Genesis Solar Energy Project Eastern Riverside County, California

**Amendment
(09-AFC-8)**

DOCKET 09-AFC-8C

April 2012

**FIGURE 2
OPTIONS A & B
VIEW 1**

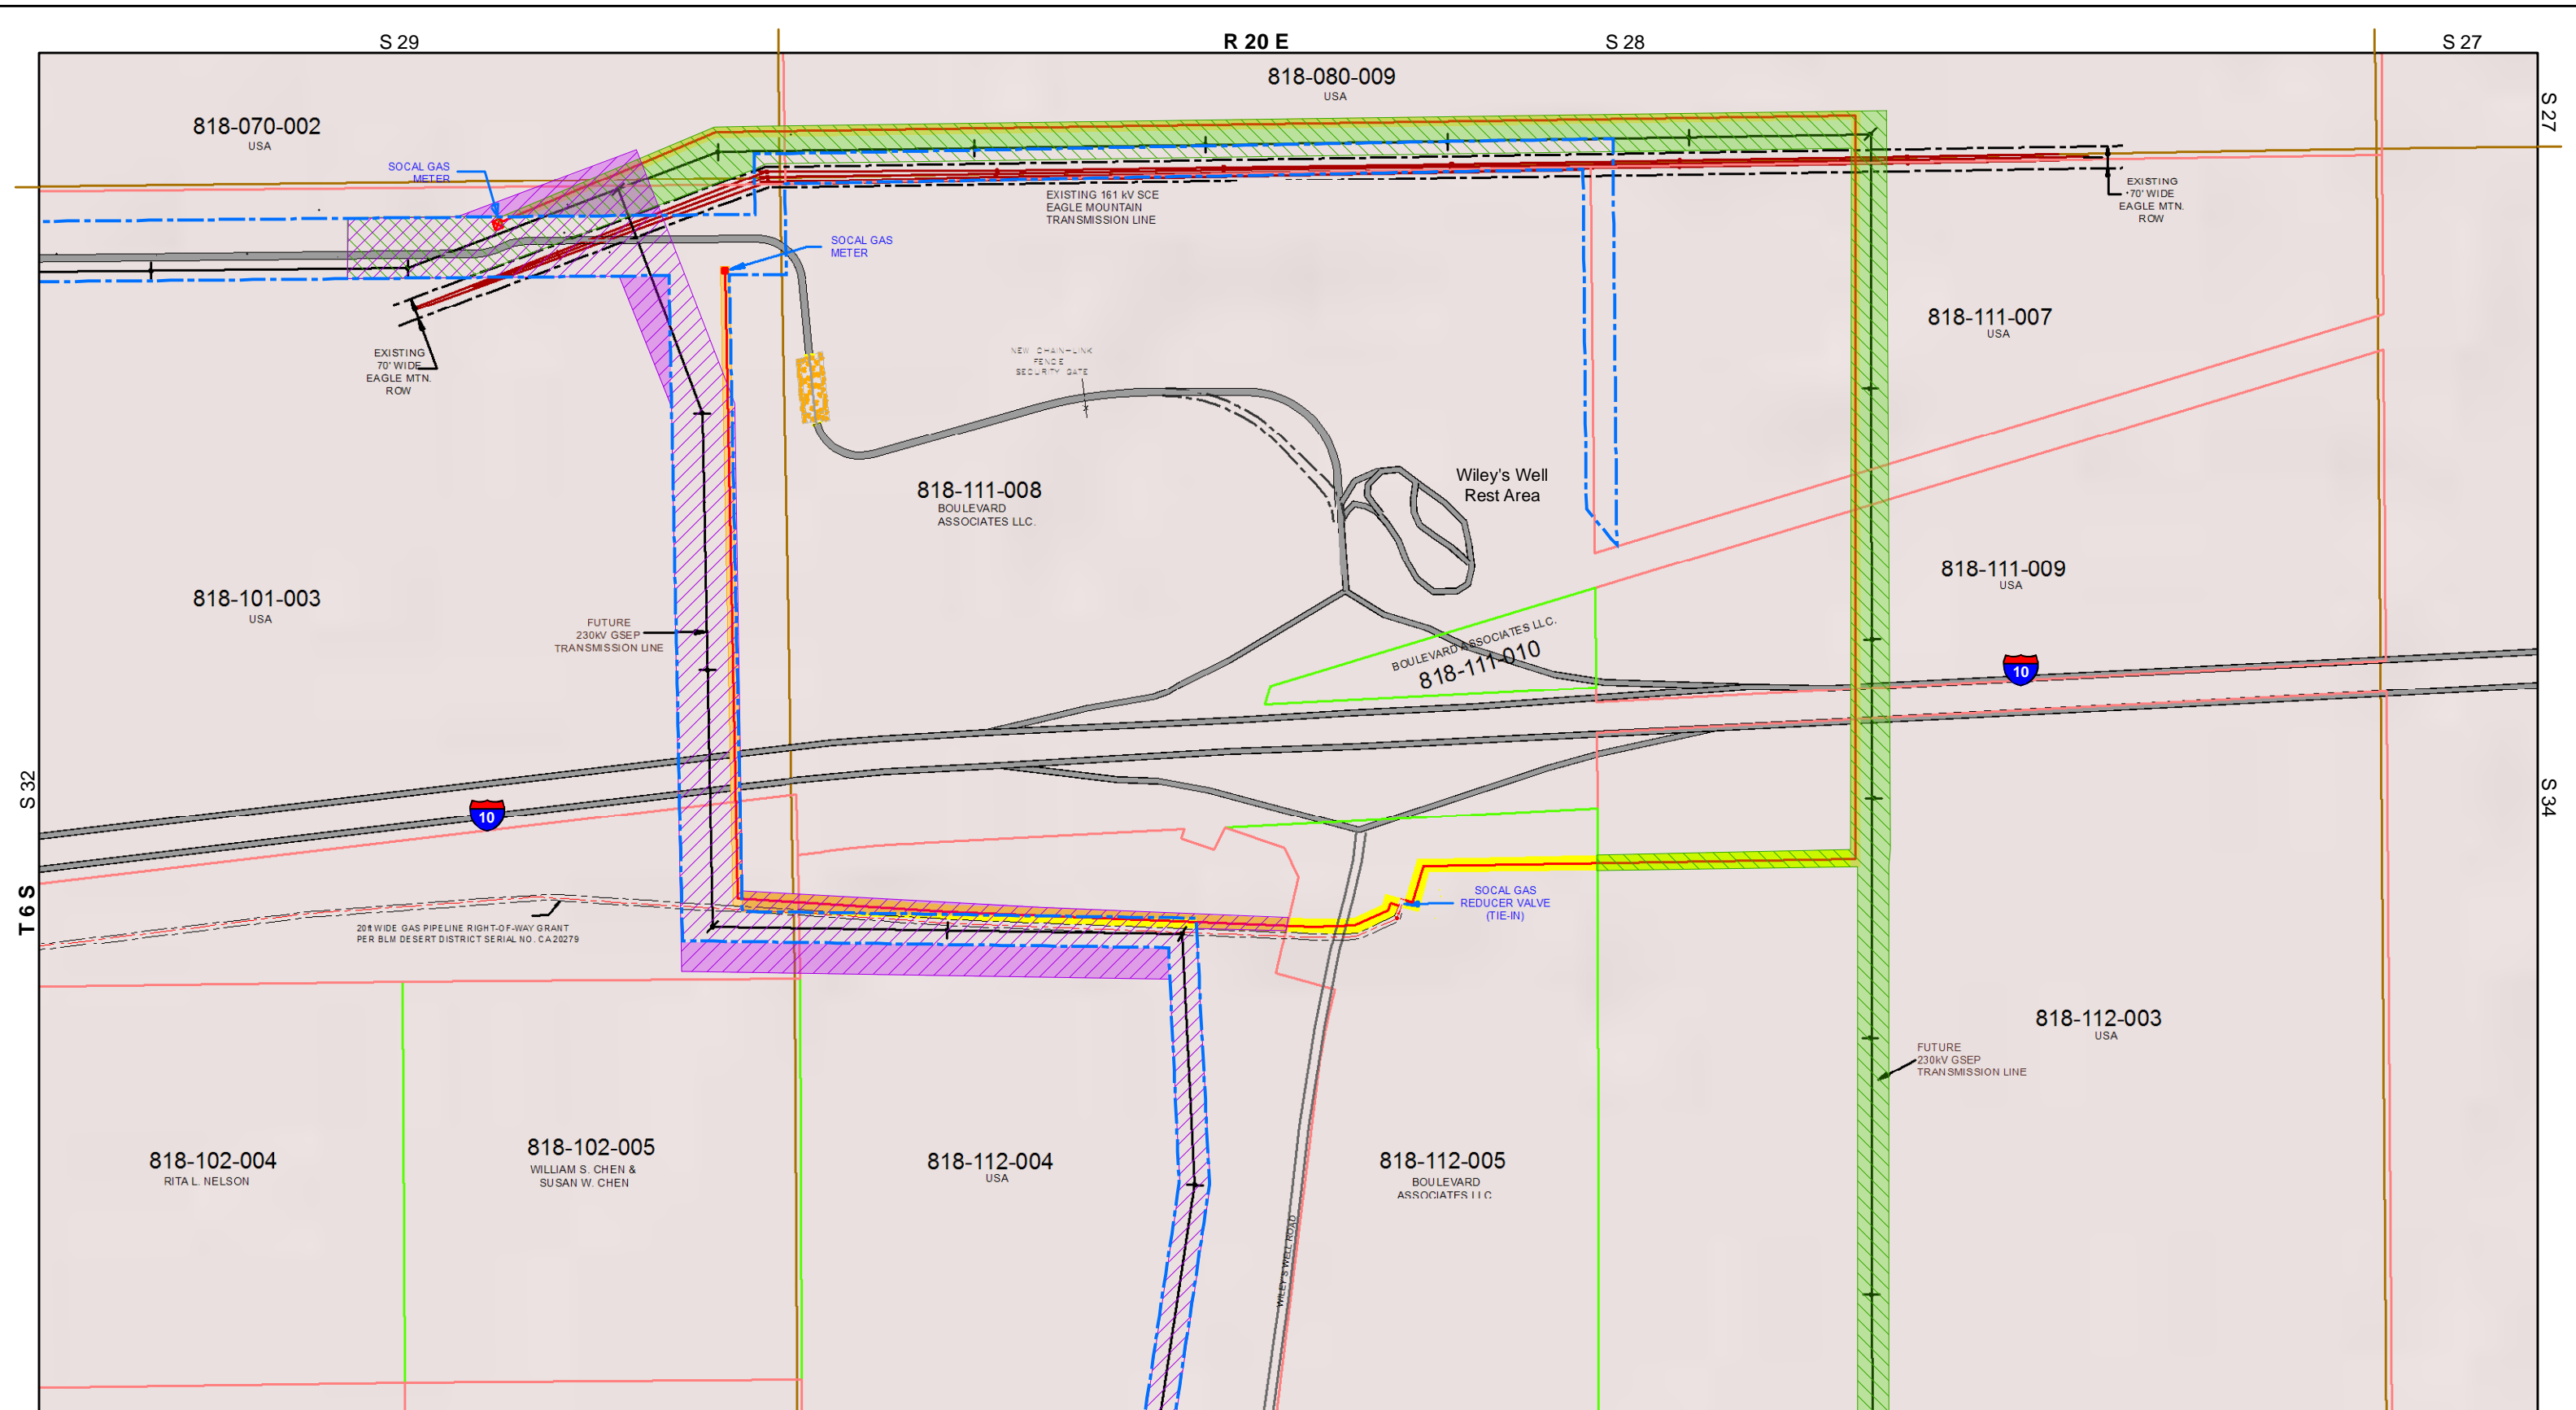
This option is the permitted gen-tie route currently in the CEC Final decision and BLM ROW; however, changes are needed to the ROW to allow the gen-tie to cross the SCE Eagle Mountain 160 kV line and tie into the BETL. Figure 2, View 1 shows the modifications to the ROW necessary to cross the Eagle-Mountain line. SCE requires that non-SCE transmission lines cross their system lines at a 90 degree angle (i.e. perpendicular). The presently-approved ROW does not provide sufficient room to facilitate that crossing. The approved gen-tie route in this area reflects a due-east path from the GSEP Plant Site until the gen-tie crosses over Eagle Mountain line at a 20 degree angle. The GSEP line then continues east within the approved ROW for approximately 540 ft. before turning due south within the approved ROW. The proposed gen-tie route also reflects a due-east path from the GSEP Plant Site to a point approximately 300 ft. west of Eagle Mountain Line. To cross the Eagle Mountain line at a perpendicular angle, the GSEP line will then need to turn east-northeast, paralleling the Blythe-Eagle Mountain line for approximately 675 ft., before turning south-southeast (perpendicular) for approximately 720 ft. to a point within the approved ROW. Two new turning structures will be required to cross the Eagle Mountain line at a perpendicular angle. The GSEP line will then continue south within the approved ROW.

**FIGURE 3
OPTIONS A & B
VIEW 2**

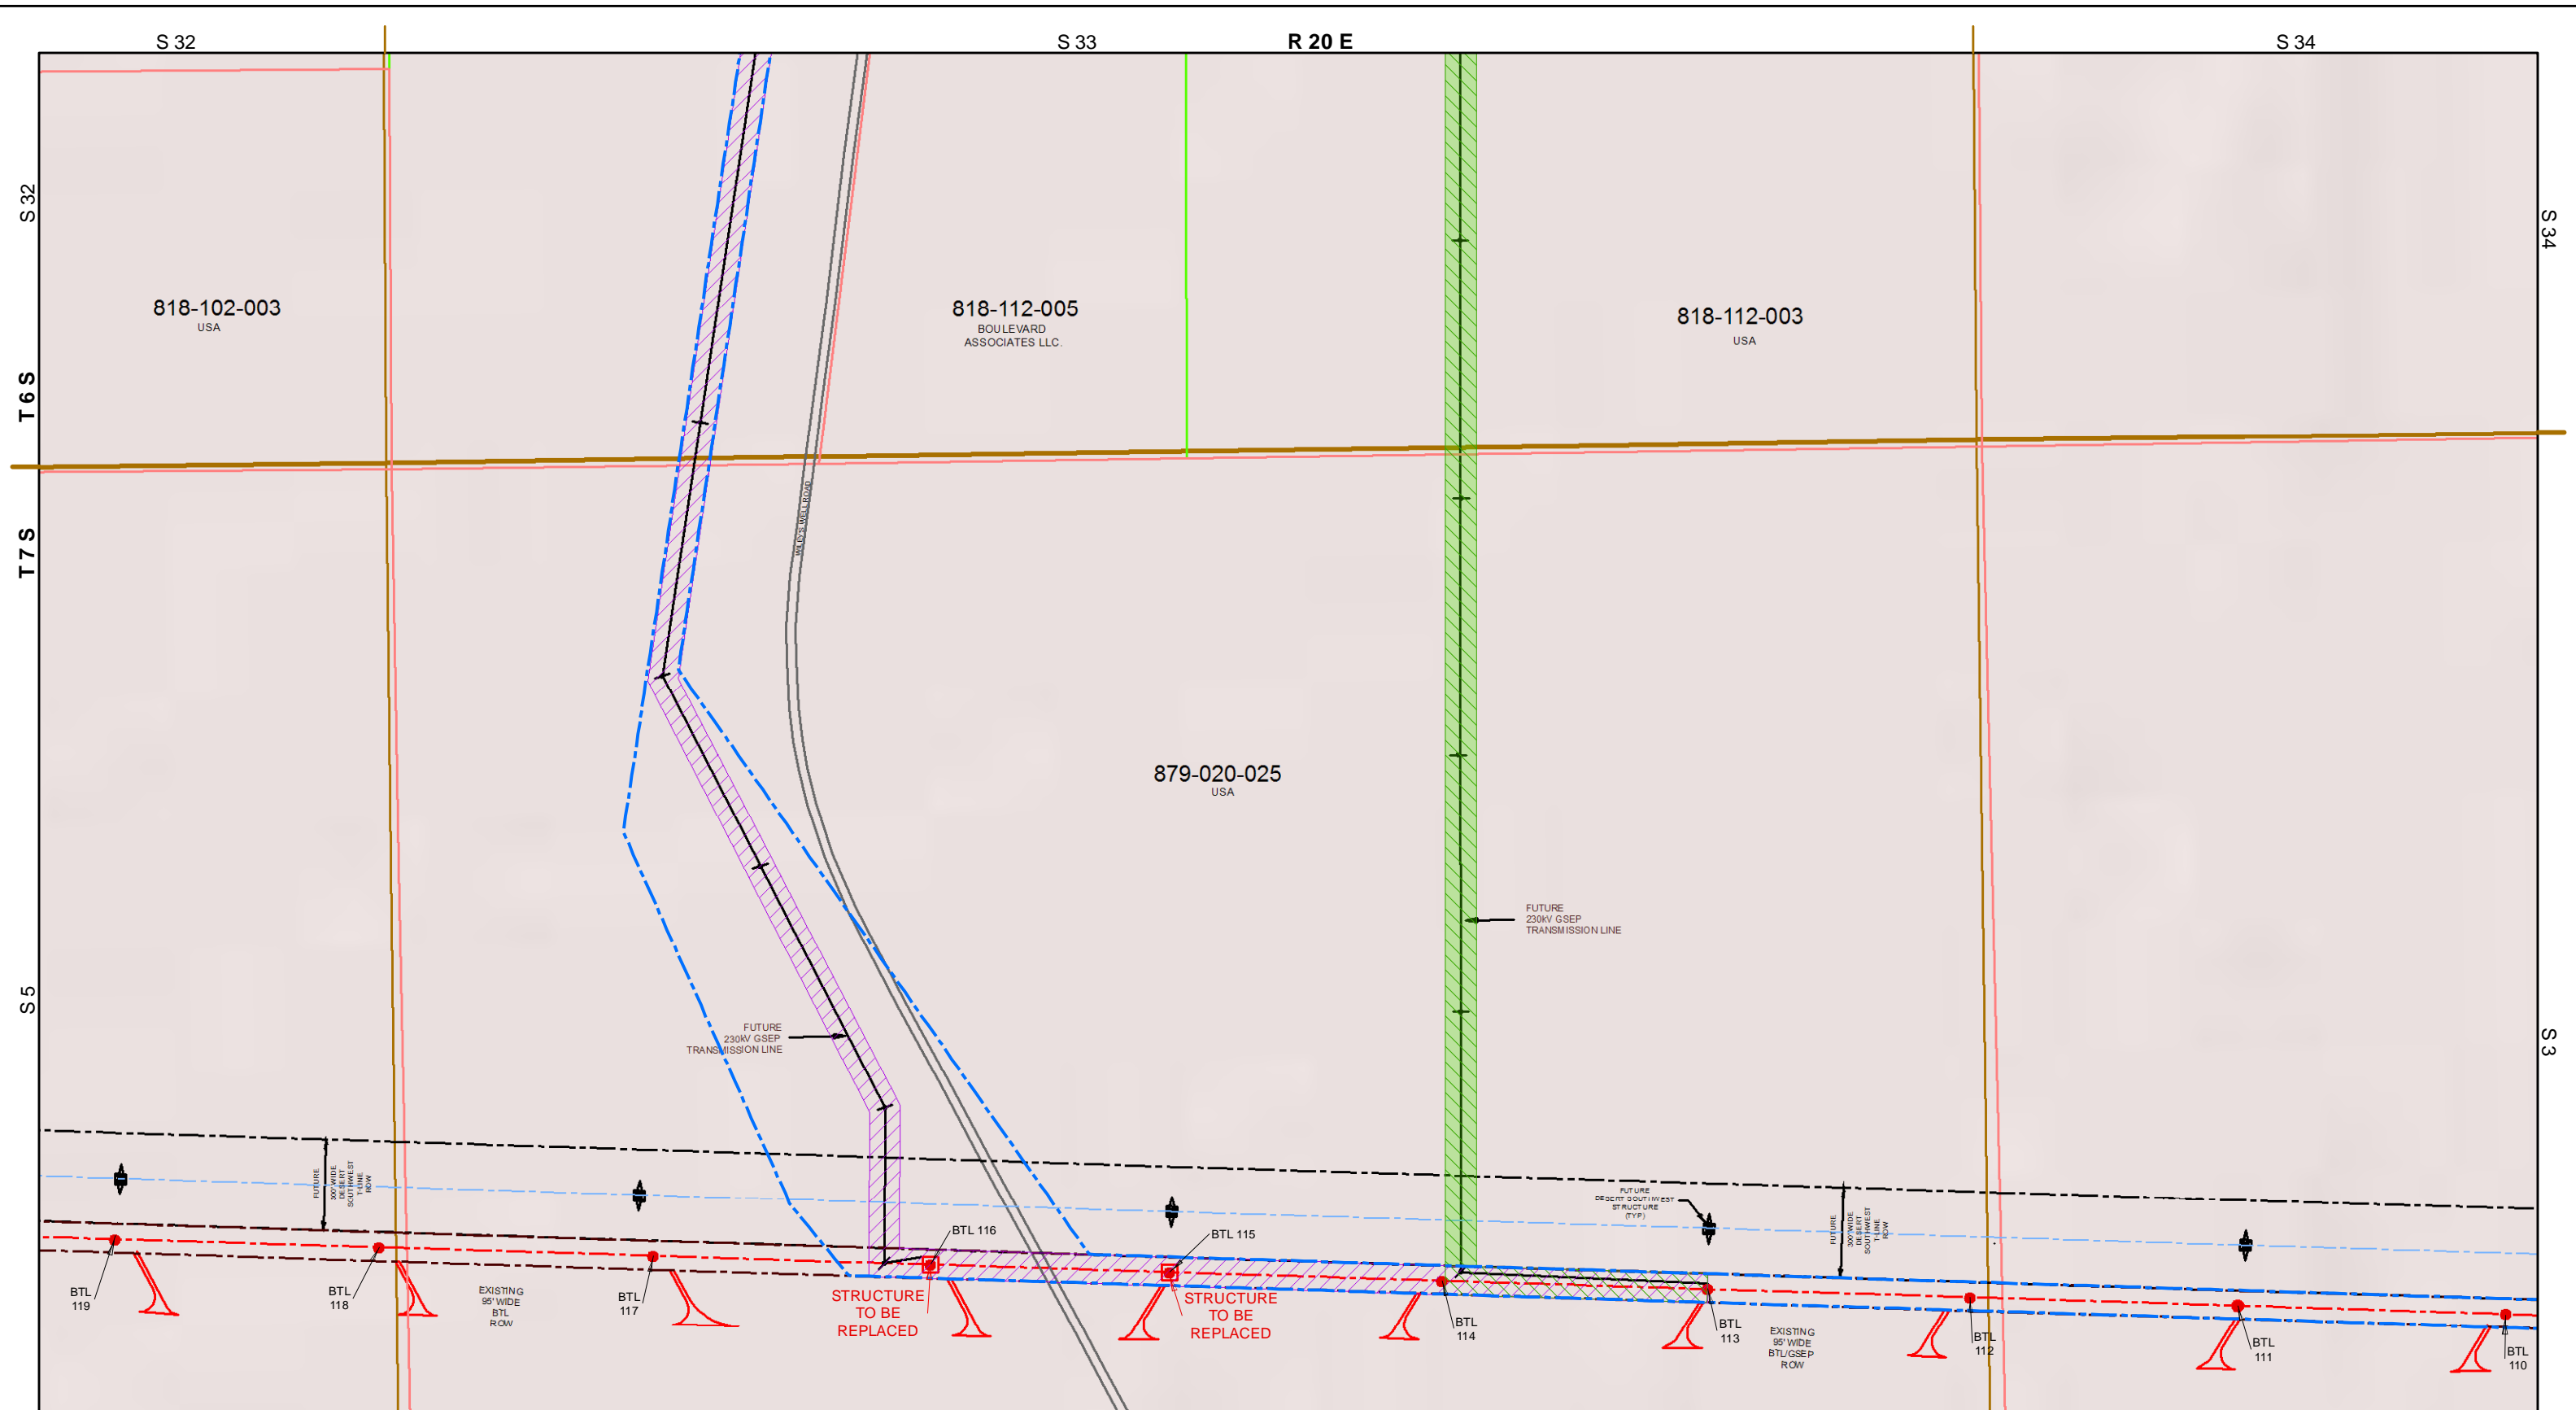
Figure 3, View 2 shows the location of the GSEP gen-tie entering the ROW of the BETL. One turning structure will be needed immediately north of the Desert Southwest ROW to span the future line and connect into BETL. A new pole will need to be added west of BETL pole number 116 to facilitate the connection of the GSEP line to BETL. Because BETL Poles 116 and 115 are currently single circuit, both poles will need to be exchanged for double circuit poles. BETL Poles 114 through 88 are already double circuit and the GSEP tie-line will continue along these structures without any additional pole replacements. The GSEP tie-line will exit BETL at Pole 88 as described above in Section 3.1.
